WATERFORD STEAM ELECTRIC STATION, UNIT 3

AMENDMENT TO FACILITY OPERATING LICENSE

Amendment No. 93  
License No. NPF-38

ATTACHMENT TO LICENSE AMENDMENT NO. 93

FIGURE 3.2-2

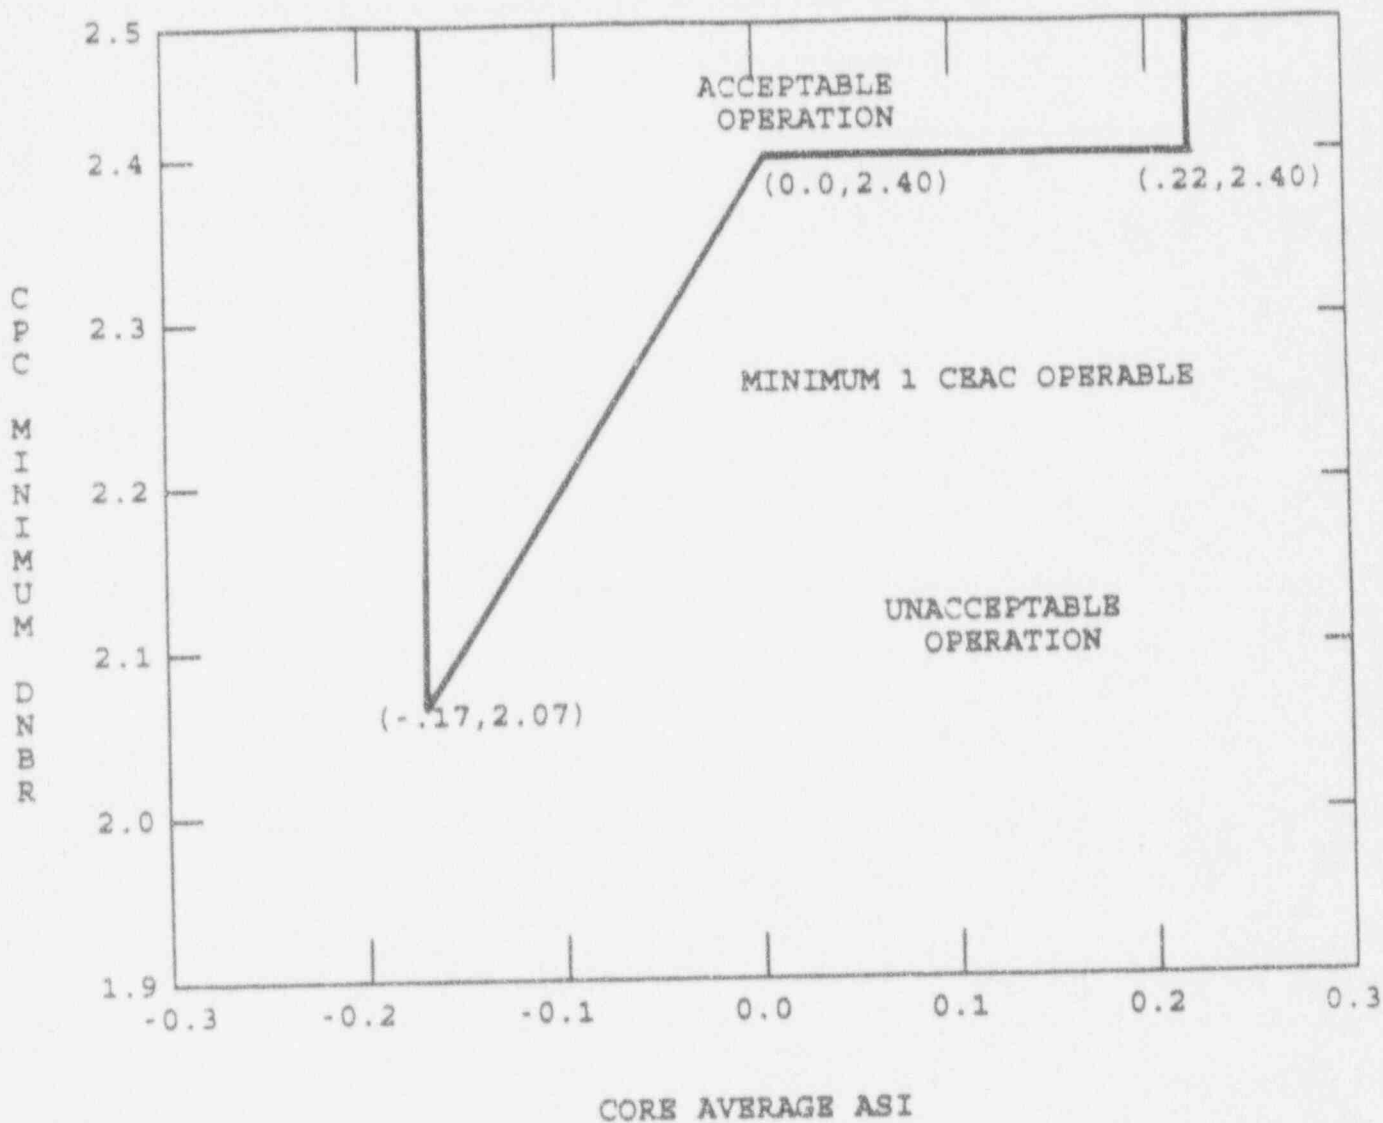
COLSS OUT OF SERVICE DNBR LIMIT LINE

DNBR MARGIN OPERATING LIMIT BASED ON CORE PROTECTION CALCULATORS  
(COLSS OUT OF SERVICE, CEACs OPERABLE)
